# NPP Lithuania

## Expert Statement to the EIA Report

Ordered by the  
Federal Ministry for Agriculture, Forestry,  
Environment and Watermanagement,  
Projectmanagement Department V/6 "Nuclear Coordination"  
GZ BMLFUW-UW.1.1.2/0013-V/6/2008

REPORT  
REP-0186

Figure 1: Core damage frequency as reported in the EIA Report compared to other sources.

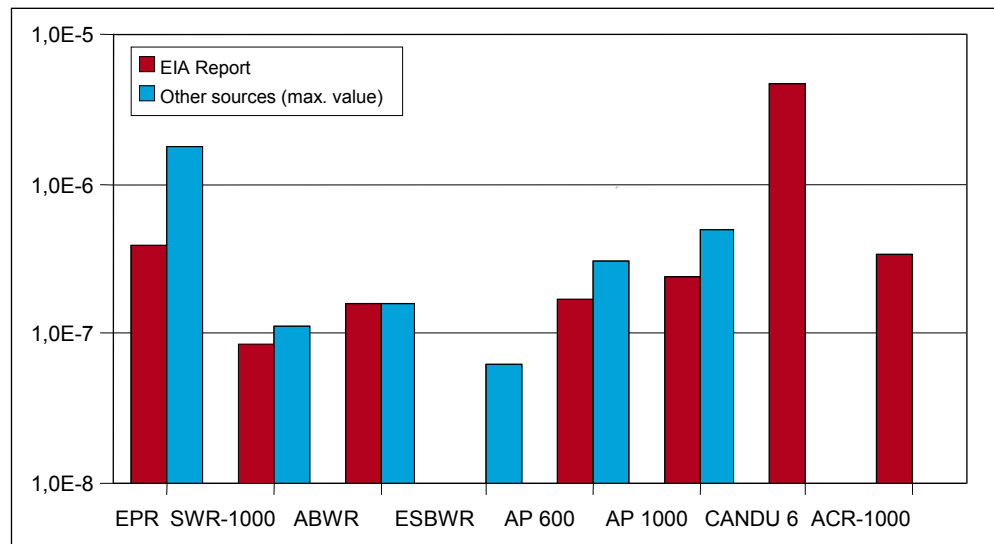
An evaluation and comparison of the numbers as provided in the EIA Report leads to the observations that CDF varies widely among reactor types – by a factor of almost 200. However, the relevance of the different CDF values for the assessment of different reactor types is not discussed in the EIA Report.

The synopsis of PSA results with their high variations and uncertainties (and possibly, inconsistencies) shows that it is not appropriate to rely too strongly on probabilistic criteria. The main criteria for the assessment of the reactor types should be deterministic.

**A detailed presentation of the PSA results of the candidate reactors would be of interest (including the contributions of different events and plant states), as well as a discussion of their limitations and the bandwidths of their uncertainty. With this background, the differences in the results as indicated above should be discussed and assessed.**

Figure 3: Core damage frequency as reported in the EIA Report compared to other sources.

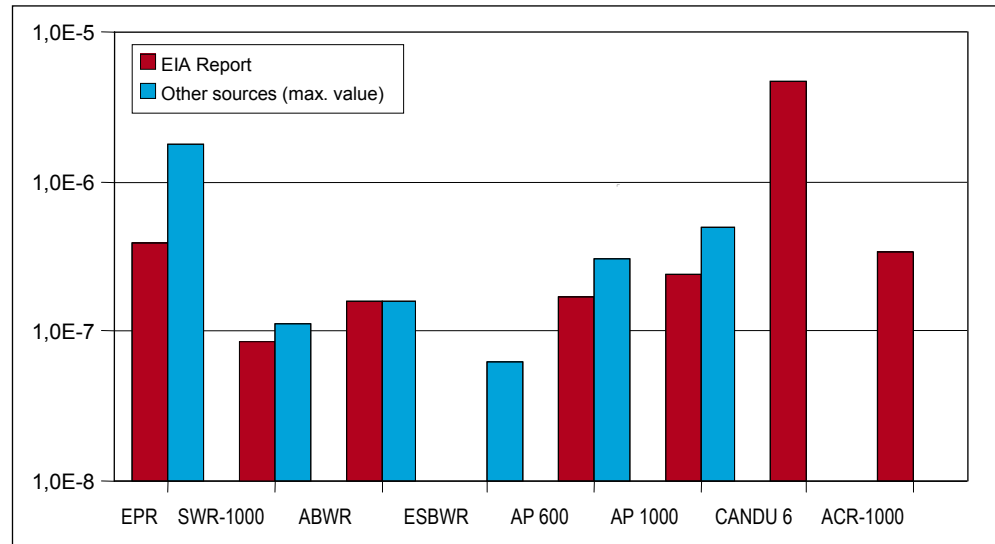
1. CDF varies widely among reactor types – the maximum value (APWR) is higher by a factor of almost 200 than the minimum value (V-448). (Even without the result for the APWR, CDFs span about two orders of magnitude.)
2. There is less variation in the reported LRFs (less than one order of magnitude).
3. The ratio between CDF and LRF varies considerably – from a factor of 6.5 (AP 1000) to factors of 460 (Enhanced CANDU 6) and 500 (V-392).
4. It is stated in the EIA Report that all candidate reactor plants meet the probabilistic requirements (CDF below 1.0E-5/yr, LRF below 1.0E-6/yr) “by a significant margin”. It appears, however, that the requirement for CDF is not fulfilled by APWR, V-392 and Enhanced CANDU-6. (Due to the uncertainties inherent in PSAs, a “significant margin” should be about one order of magnitude.)

The relevance of the different CDF values for the assessment of different reactor types and their candidate status is not discussed in the EIA Report; not even in cases where the CDF as reported in the EIA Report is close to the probabilistic requirement.

Furthermore, there is no discussion of the variations regarding the CDF/LRF ratio, and reason for the variations. Differences in the CDF/LRF ratio could indicate fundamental differences in reactor design, particularly regarding the control of core damage accidents. On the other hand, they could also be indicative of methodological inconsistencies and/or of high bandwidths of uncertainty in the level 2 PSAs of some reactor types.

Figure 4: Large release frequency as reported in the EIA Report compared to other sources.

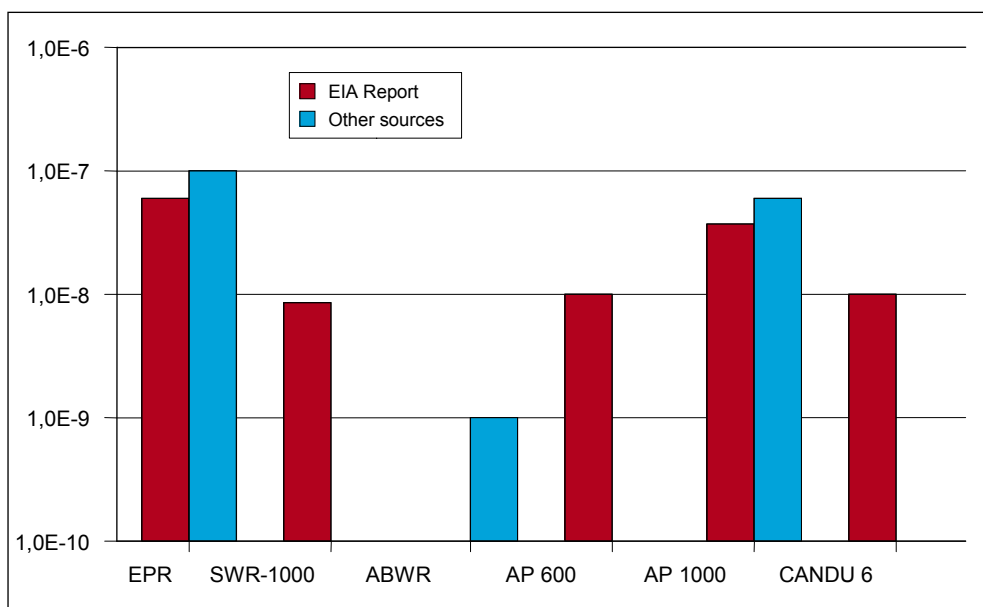
Altogether, the synopsis of PSA results with their high variations and uncertainties (and possibly, inconsistencies) shows that it is not appropriate to rely too strongly on probabilistic criteria. The main criteria for the assessment of the reactor types should be deterministic, with the results of probabilistic studies as a supplement only.
